Re: Re: Objection Submission – Concept State Significant Development Application SSD 18_9579 Sydney Metro Crows Nest Over Station Development

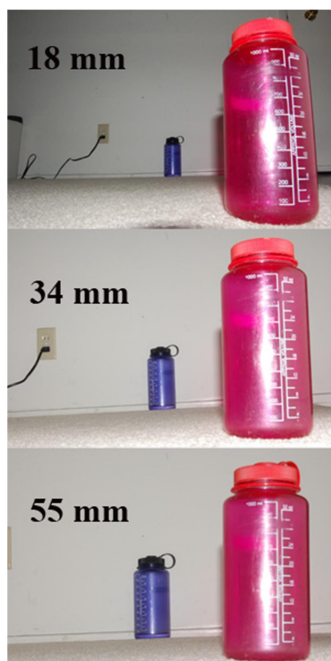
10. **Negative impacts of scale, visual intrusiveness, bulk and overshadowing caused by the proposed OSD buildings’ mass and heights are understated, misrepresented and trivialised in the Concept SSD EIS.** A few examples as evidence:- In many appendices, use is made of Figure 8 Crows Nest OSD Indicative Design (same as attached p9 of App.F Urban Design Report) – in which the Nicholson St houses and foreground trees cast long shadows on the road, but the massive OSD buildings cast almost no shadows on the Highway or low buildings opposite. The chroma for vegetation in this illustration has been misleadingly intensified to make it all look unrealistically bright, and there are - impossibly given the direction of sunlight - no shady sides shown on the Nicholson St trees. Similarly, p40 of App. F (attached) shows no shadows cast by the towers onto the land to the west of the Highway, even though the Hume St Carpark and Clarke St roof protrusion cast noticeable shadows which are shown. The latter shadows are almost identical to those cast at 9am on 21 March (see App.J attached) BUT in this App.J Shadow Diagram , there are HUGE SHADOWS cast to the west by the OSD. It is obviously misleading to not show these shadows in the Urban Design report renderings. The

Shadow Diagrams, too, make use of colour to assist a false impression, using a bright canary yellow to alter the viewer's mental response to the impact of the large areas of "happy" shadow cast by the OSD. The OSD buildings do indeed tower intrusively over surrounding low-rise areas, will reduce their privacy, and create much more shadow than often depicted. Such a manipulation is concerning indeed, as it is hard to detect. The village atmosphere is destroyed needlessly because the OSD could be much lower in height and contain village-enriching community uses.
